Figure 15.6.3-1

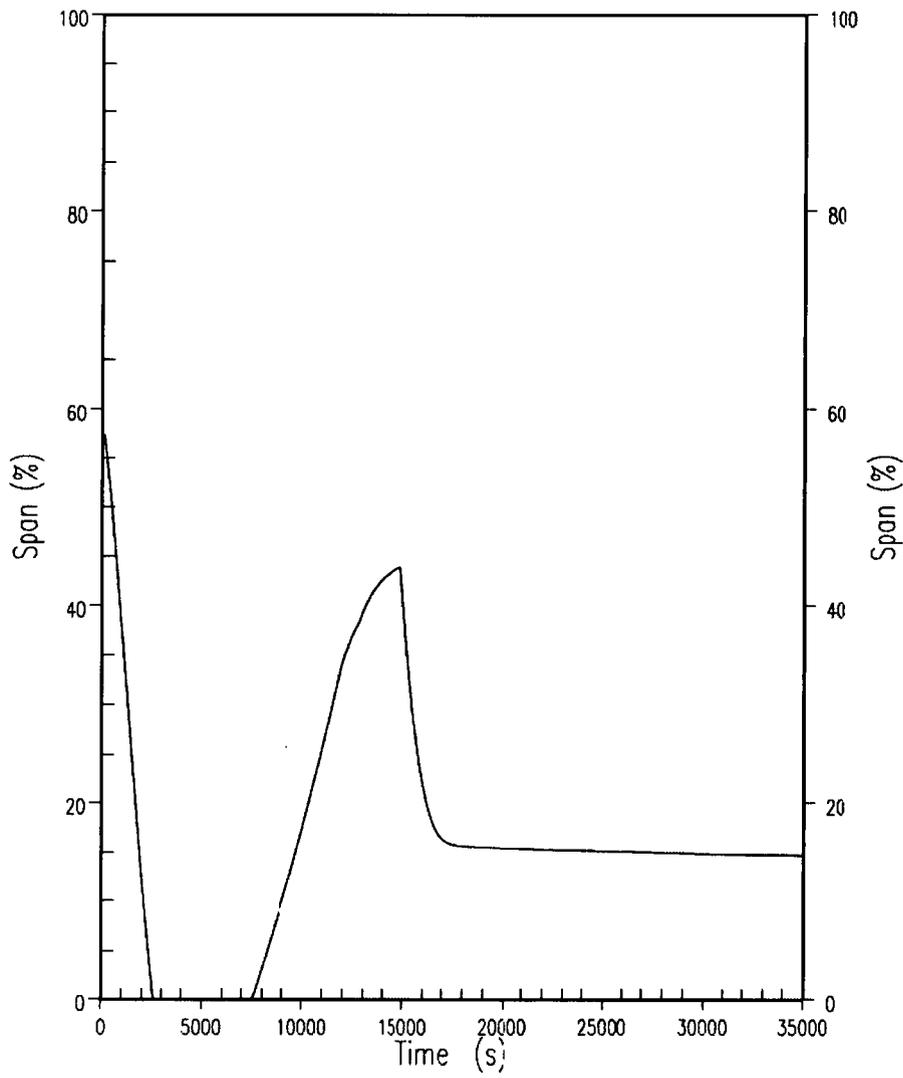
Comment [B71]: [15.6-69]
